Commonwealth Edison

October 8, 1981

Subject: Proposed Changes to the LaSalle
Technical Specification

Fig.1 - System Schematic Diagram, "S" Units

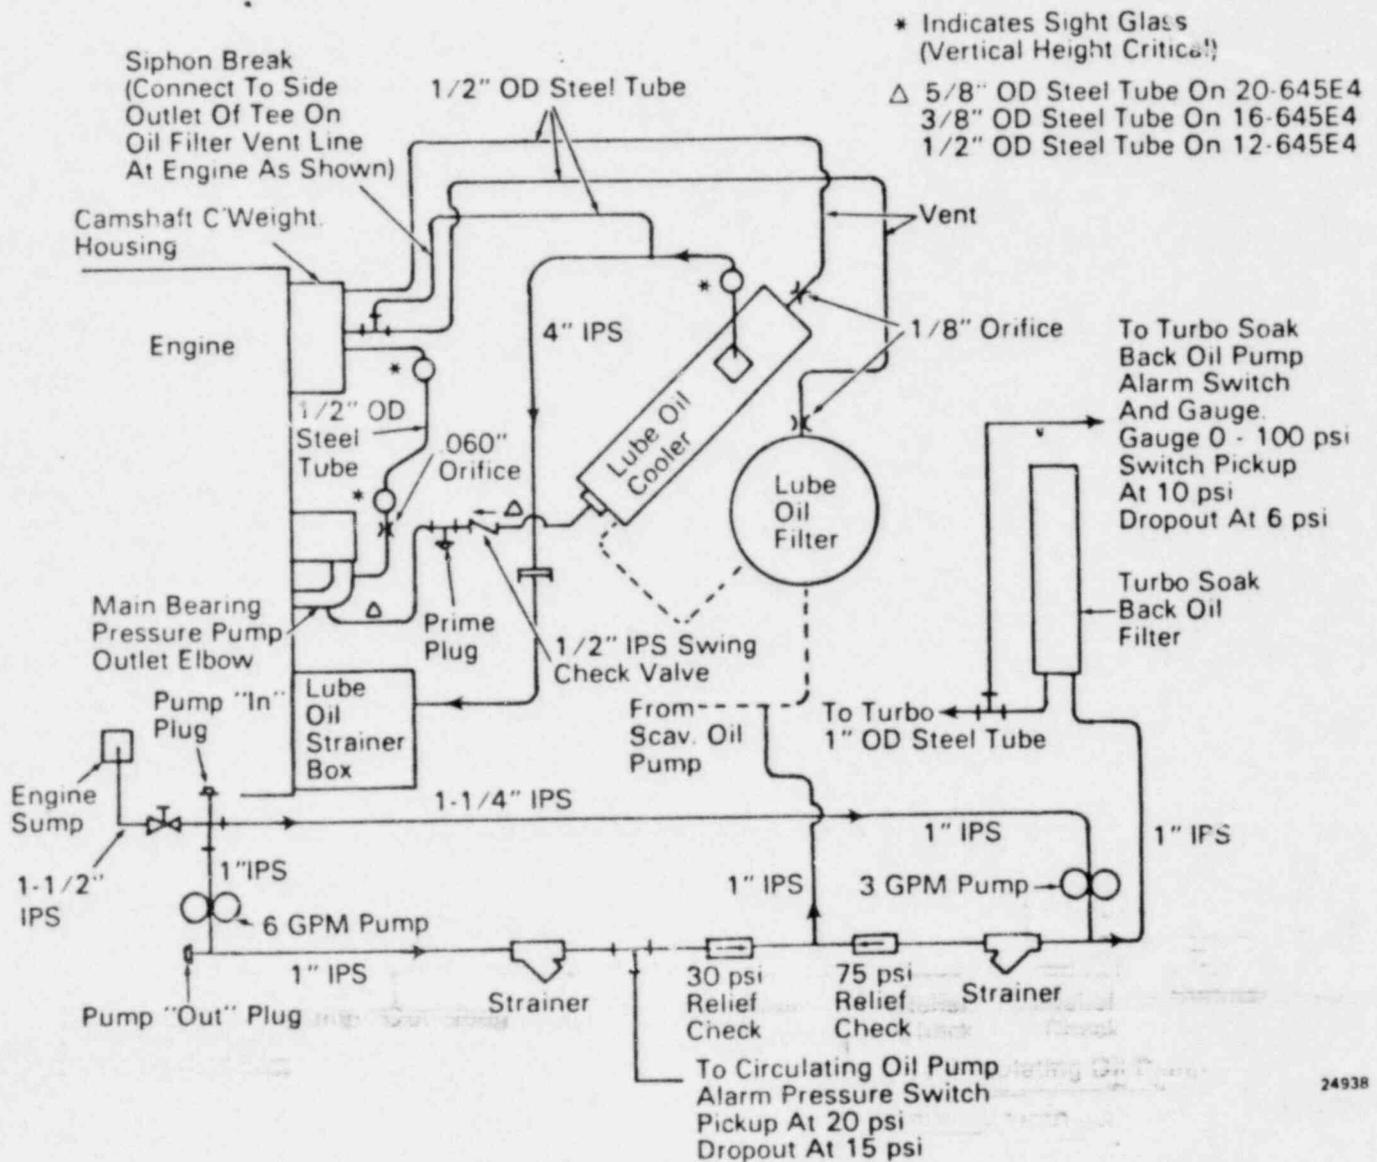
Figures 1 and 2 illustrate a schematic diagram of the proposed modification to the LaSalle diesel generator lubrication system. Completion of this modification should address the concerns in SER Section 9.6.3.4.

PURPOSE: To provide an improved immersion heater lube oil circulating system, Figs. 1 and 10, that will consistently supply oil to the turbocharger and crankshaft in anticipation of an emergency start.

The primary benefit to be gained from this modification is continual oil replenishment of the oil cooler and filters to the full level regardless of oil temperature and viscosity. It would also remove restart restrictions imposed on exercise or test schedules.
